TYPICAL SECTIONS

PHASE 1 - KAUMUALII HIGHWAY
LIHUE MILL BRIDGE TO RICE STREET

PHASE 3 - REHABILITATION OF LIHUE MILL
BRIDGE AND MAKAI WIDENING

"AS-BUILT"

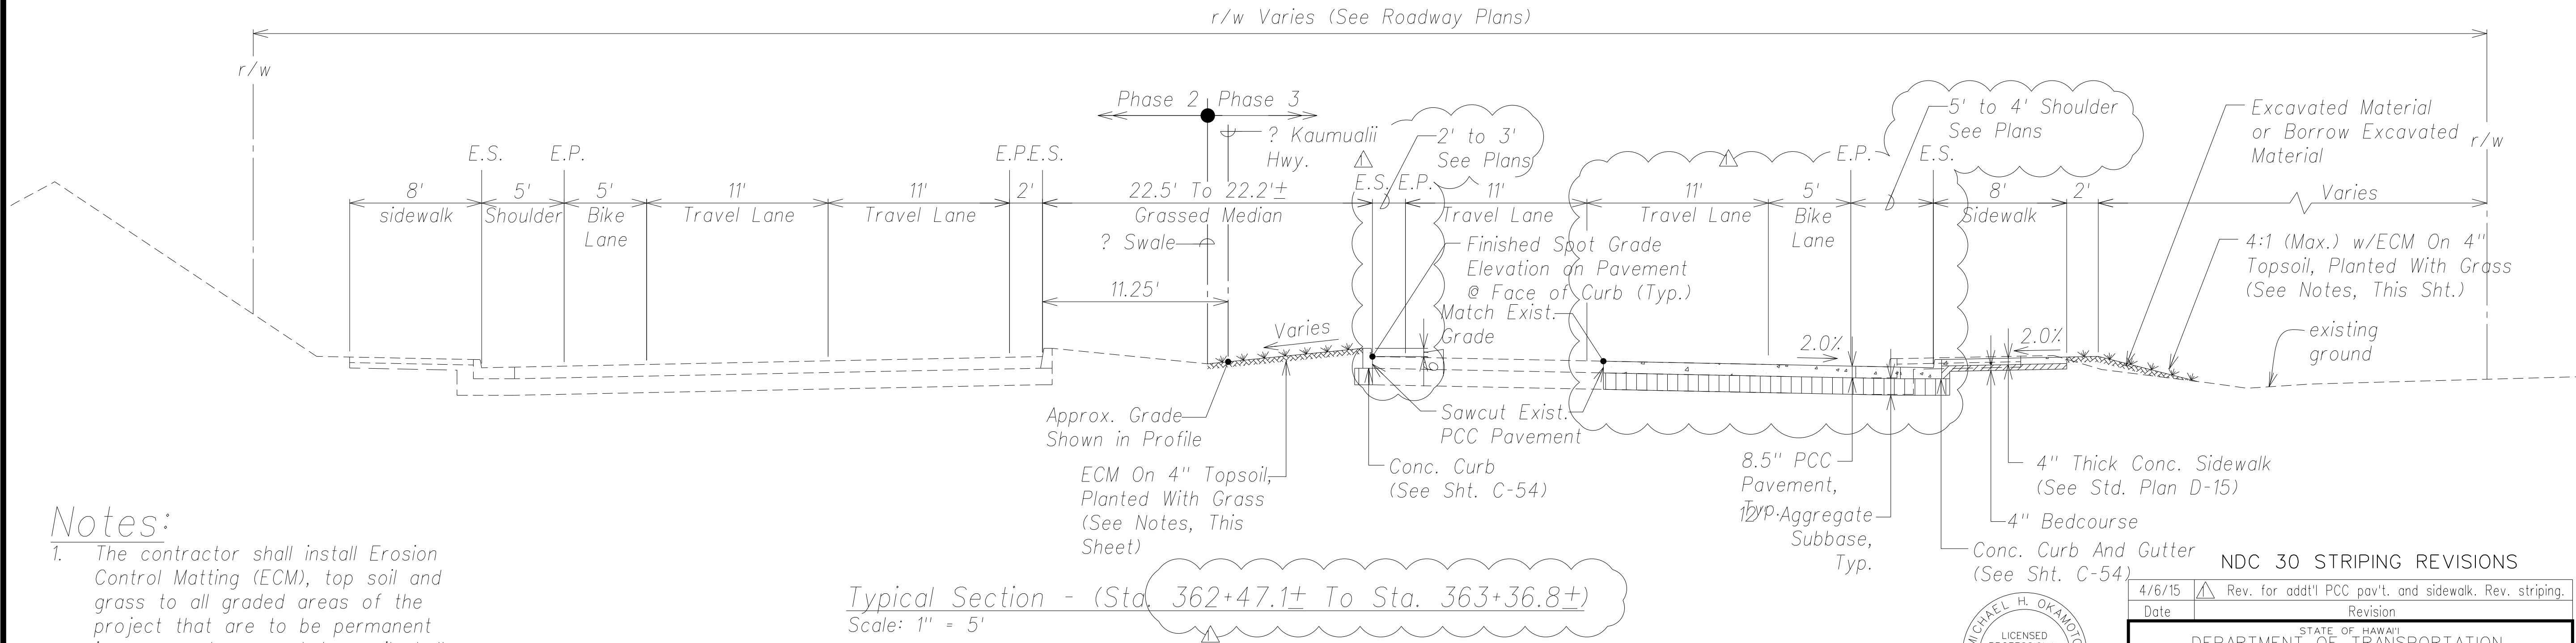
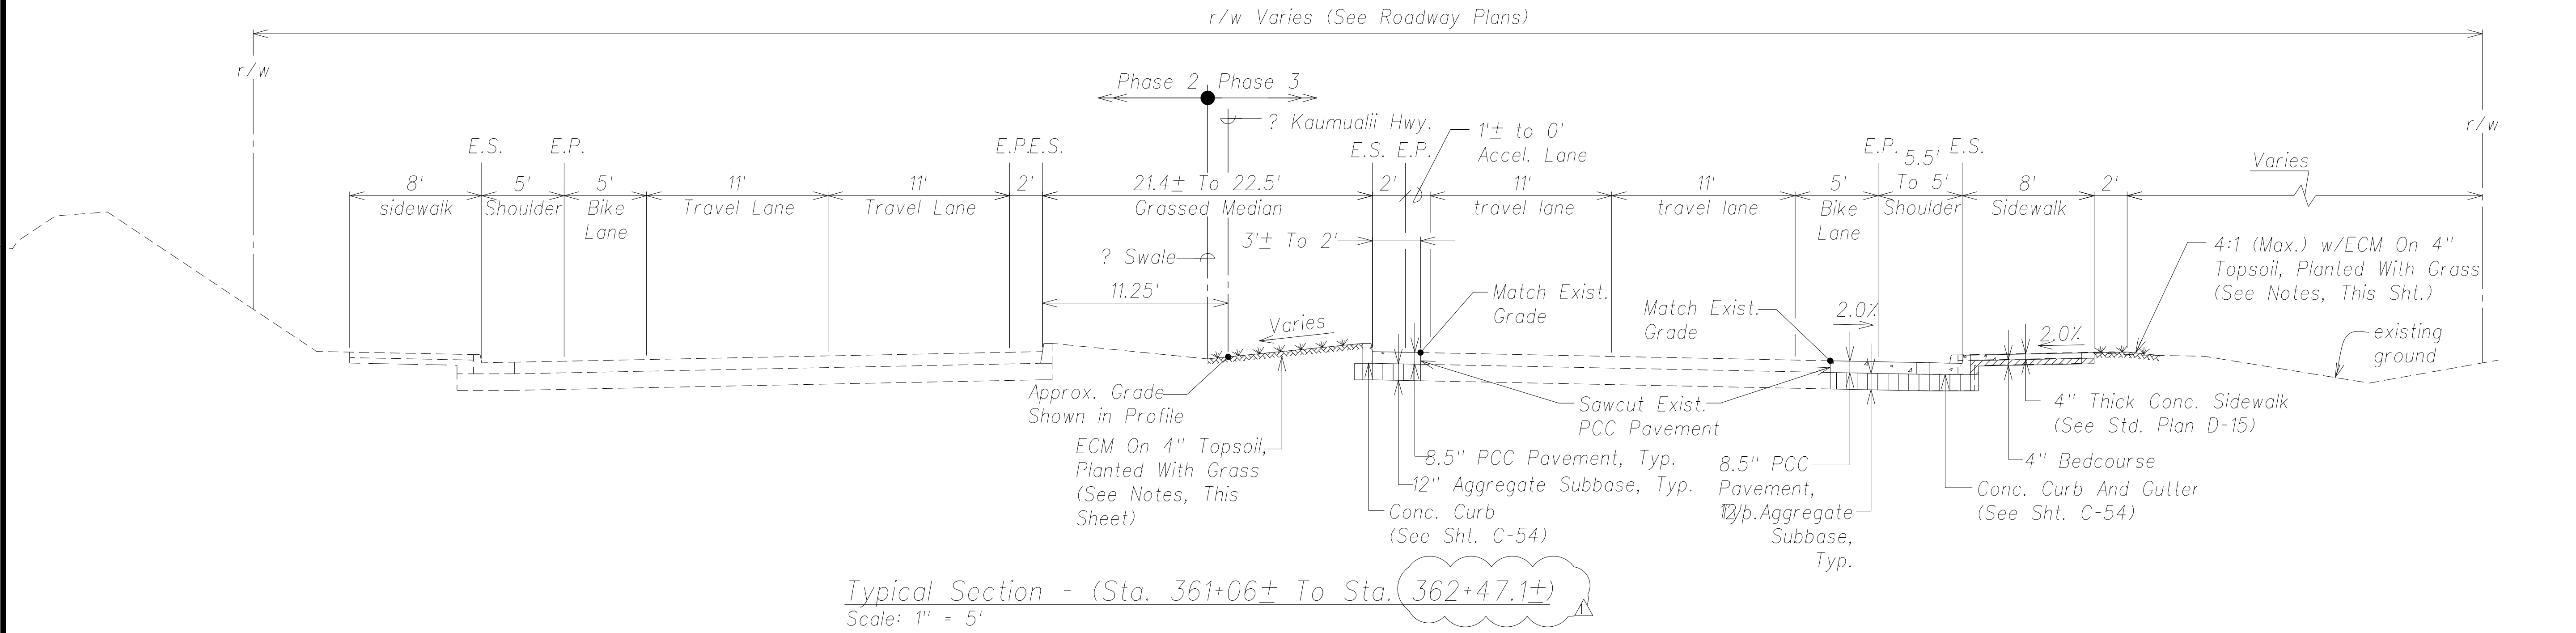
NDC 30 STRIPING REVISIONS	
4/6/15	Rev. for add'l PCC pav't. and sidewalk. Rev. striping.
Date	Revision
STATE OF HAWAII DEPARTMENT OF TRANSPORTATION HIGHWAYS DIVISION	
TYPICAL SECTIONS	
PHASE 1 - KAUMUALII HIGHWAY LIHUE MILL BRIDGE TO RICE STREET	
PHASE 3 - REHABILITATION OF LIHUE MILL BRIDGE AND MAKAI WIDENING	
Scale: As Shown	Date: May 2, 2014
SHEET No. C-15 OF 82 SHEETS

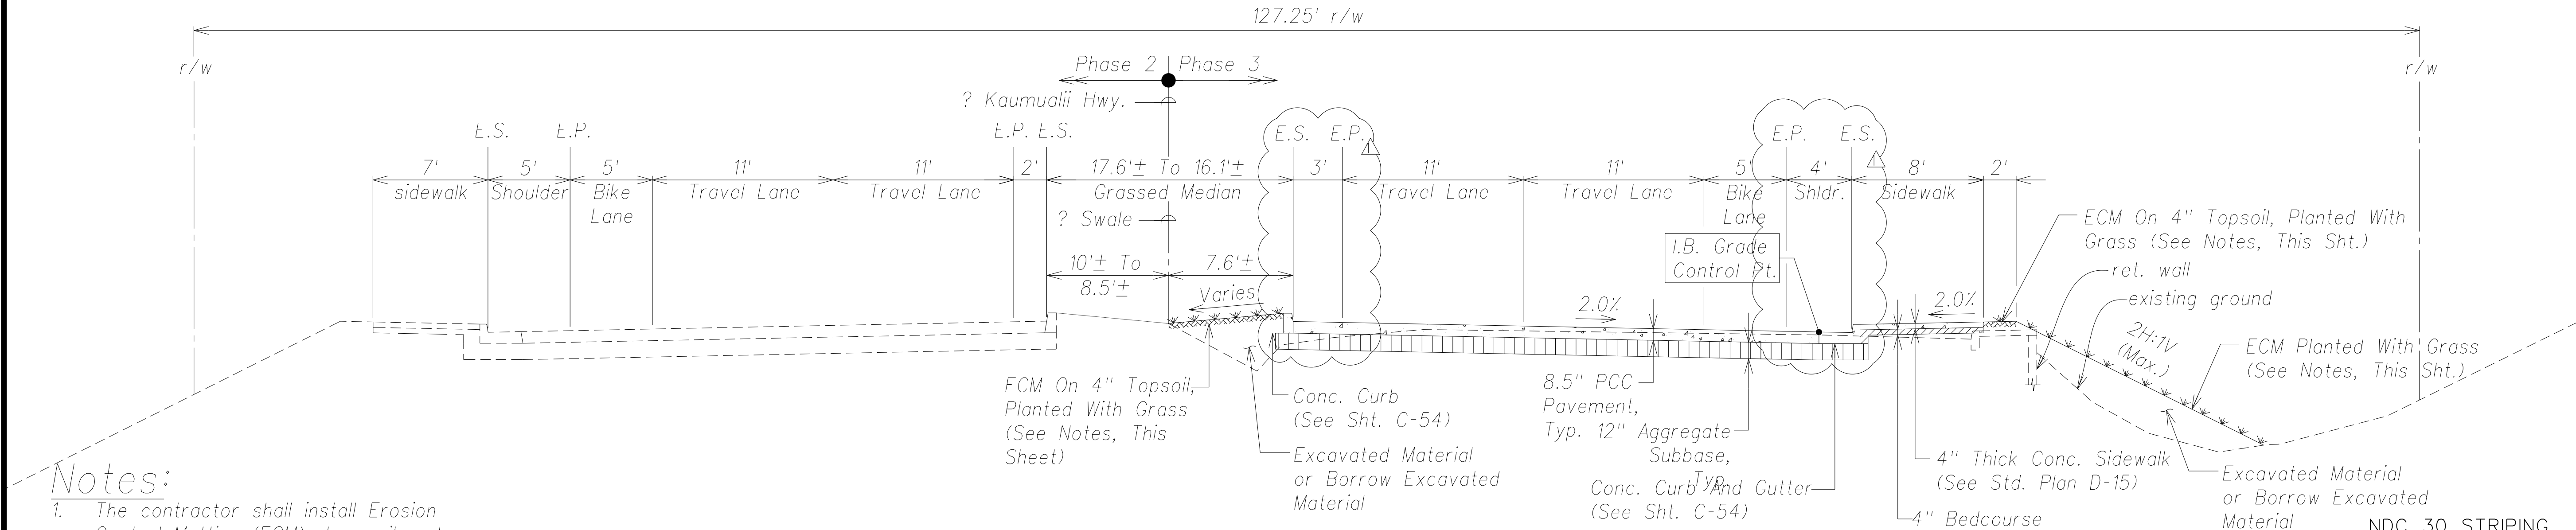
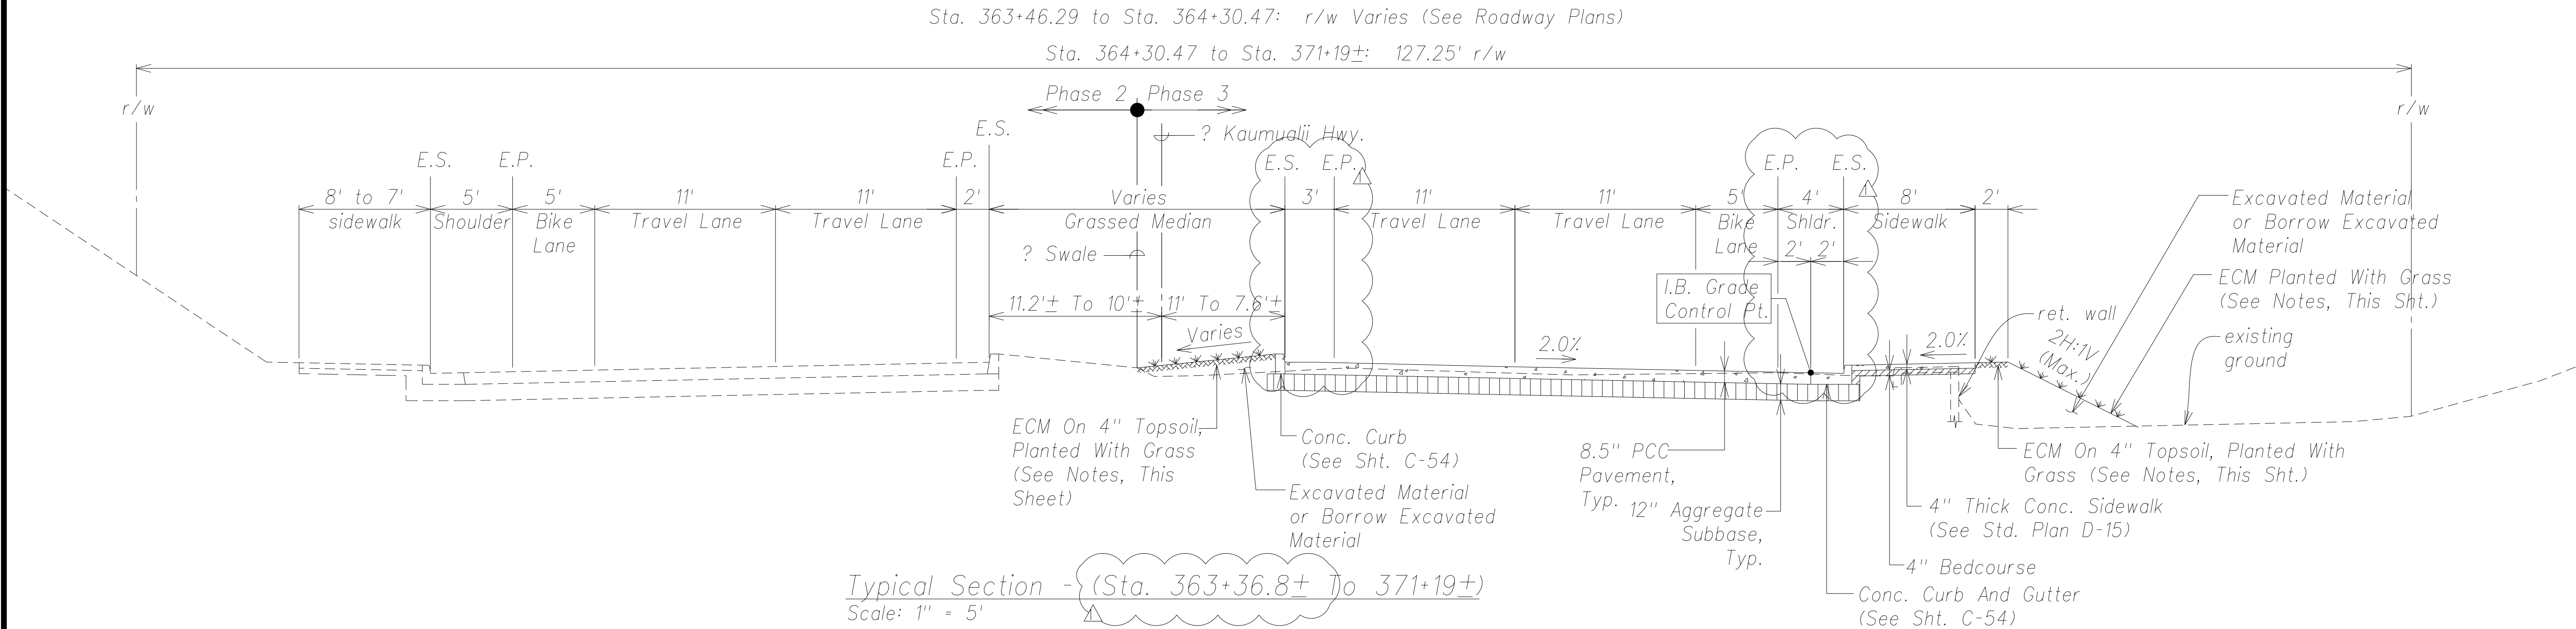
NDC 30 STRIPING REVISIONS	
4/6/15	Revise striping.
Date	Revision
DEPARTMENT OF TRANSPORTATION HIGHWAYS DIVISION	
TYPICAL SECTIONS	
PHASE 1 - KAUMUALII HIGHWAY LIHUE MILL BRIDGE TO RICE STREET	
PHASE 3 - REHABILITATION OF LIHUE MILL BRIDGE AND MAKAI WIDENING	
Scale: As Shown	Date: May 2, 2014
SHEET No. C-16 OF 82 SHEETS

SHEET No. C-19 OF 82 SHEETS

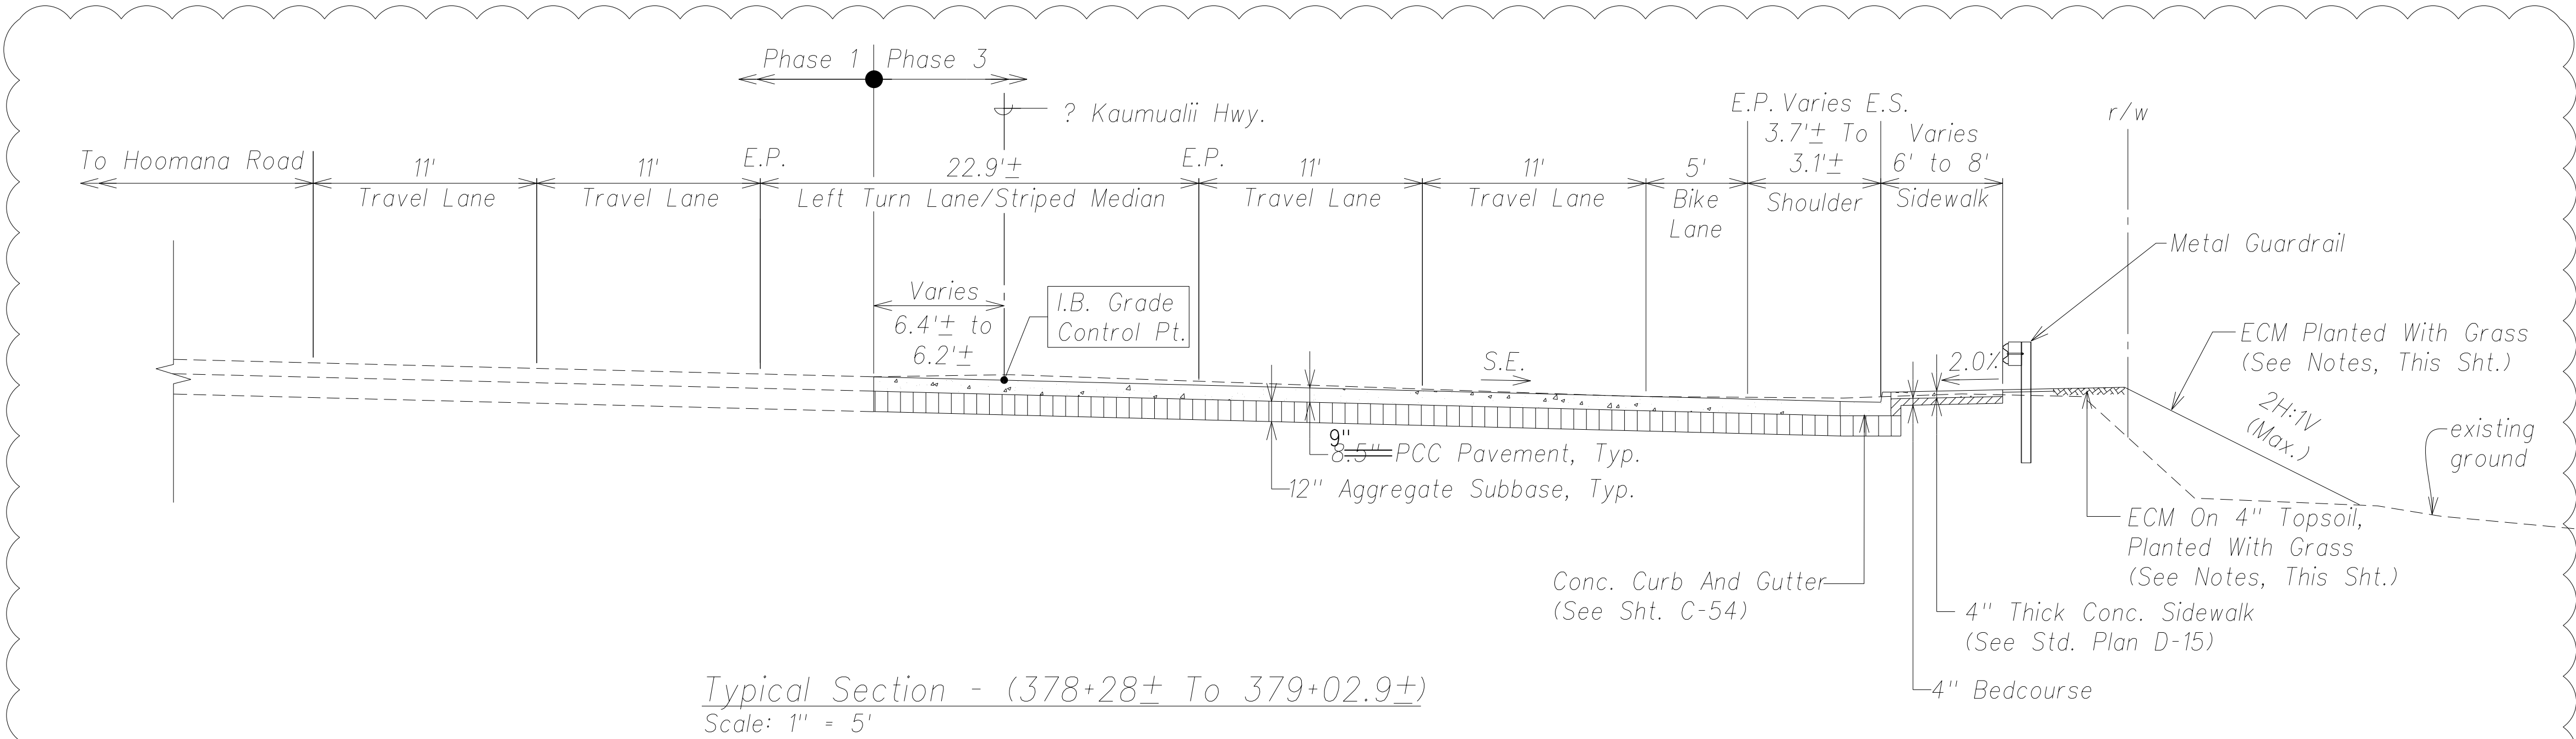
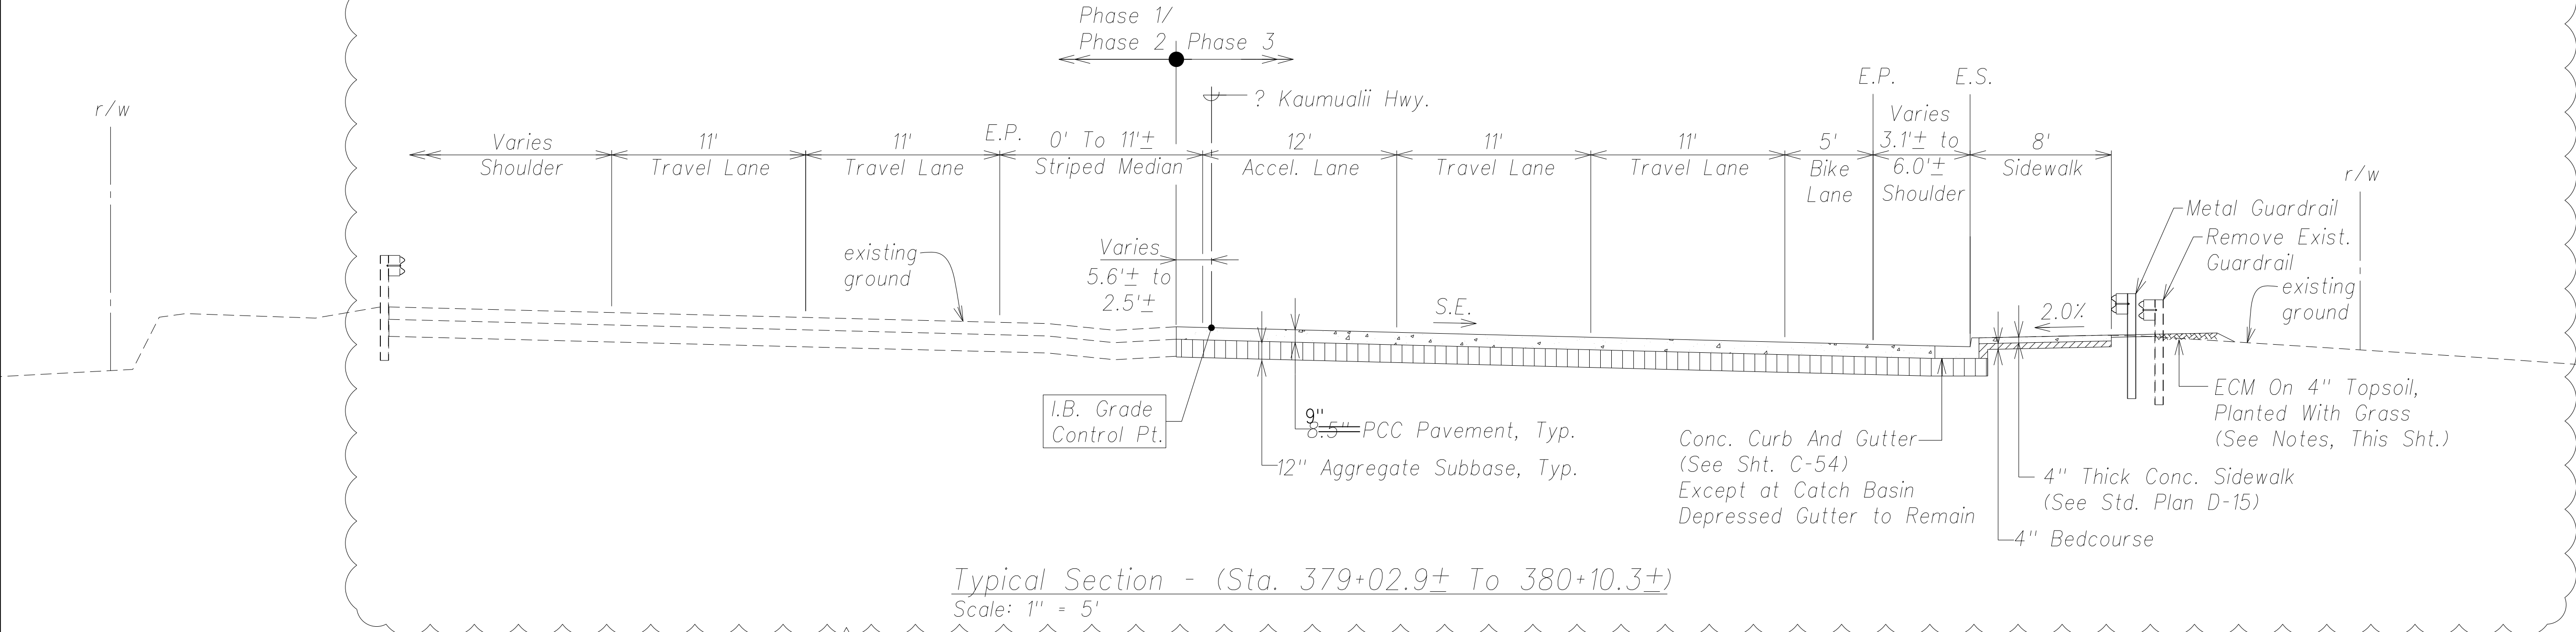
4/6/15	Revise for additional PCC pavement and sidewalk work
Date	Revision
